United States Patent and Trademark Office

APPLICATION NO.	FILING DATE	FIRST NAMED INVENTOR	ATTORNEY DOCKET NO.	CONFIRMATION NO.
10/663,649	09/17/2003	Hui-Tsang Chang	BHT-3111-361	3811
7:	590 08/11/2004		EXAMINER	
BRUCE H. TI SUITE 1404	ROXELL		FIGUEROA	, FELIX O
5205 LEESBURG PIKE			ART UNIT	PAPER NUMBER
FALLS CHURCH, VA 22041			2833	
			DATE MAILED: 08/11/200	4

DETAILED ACTION

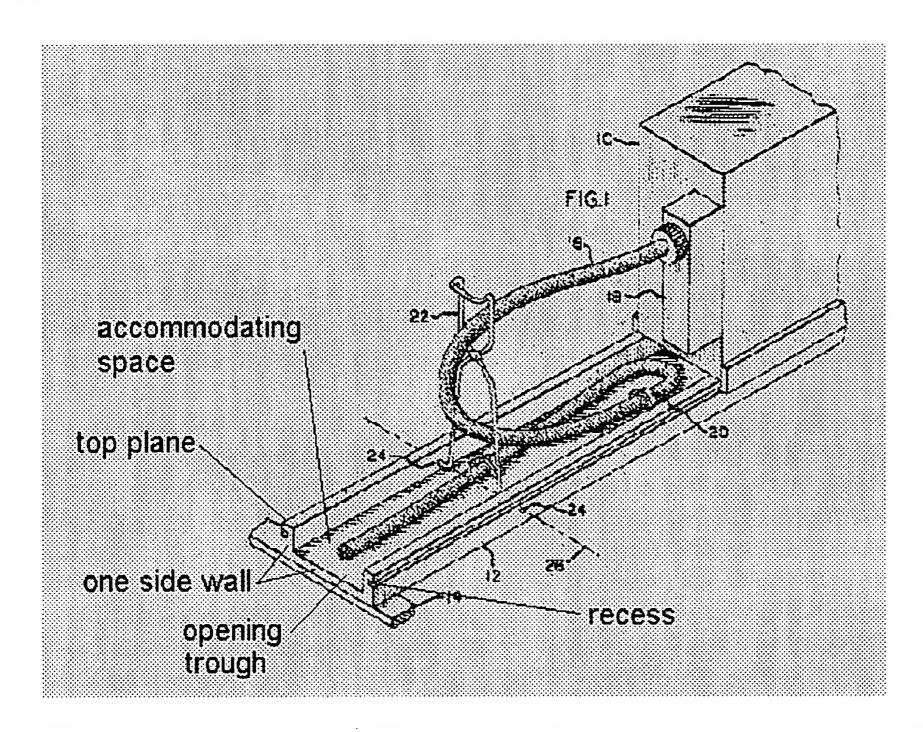
Schultz discloses a modular cable-holding device (12) for supporting an electronic device (10) connected with a cable (16), comprising: a top plane (not labeled, see following Fig.) connected with the electronic device; two side walls (not labeled, see following Fig.) deployed at two opposing sides of the top plane for propping the top plane up an appropriate altitude and forming an accommodating space (not labeled, see following Fig.) for receiving the cable, wherein at least one side wall has an opening trough; and a hooking element (22) deployed in the accommodating space for holding the cable.

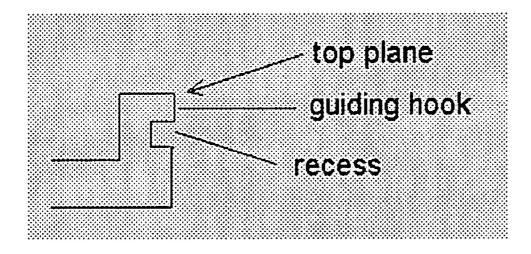
Tomino teaches an opening trough (205) with a neck part to restrain the location of the cable. Therefore, it would have been obvious to a person of ordinary skill in the art at the time the invention was made to form the opening trough of Schultz with a neck part, as taught by Tomino, to better organize and restrain the location of the cable.

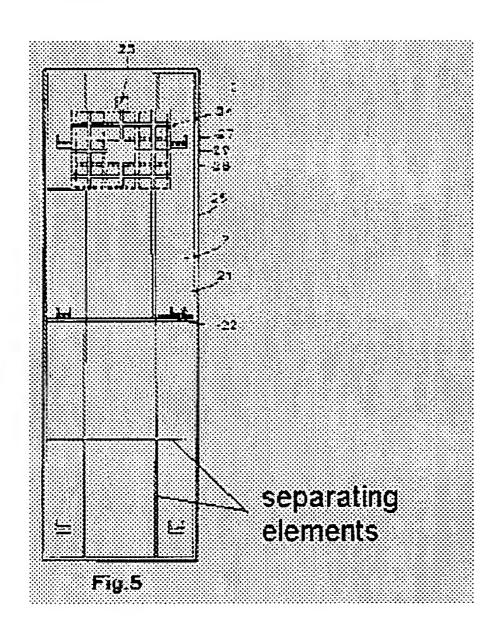
Regarding claims 2 and 3, Schultz discloses the top plane comprising a recess for supporting the electronic device and a guiding hook (see following Fig.).

Regarding claims 6 and 7, Schultz discloses the cable passing through the opening trough and entering the accommodating space in a first direction, and exiting the accommodating space in a second direction through the opening trough after the cable wind around the hooking element (when the electronic device is on the fully inserted position, i.e. all the way to the right in Fig.3); and wherein the first direction and the second direction are towards two opposite directions. See column 3 lines 8-19.
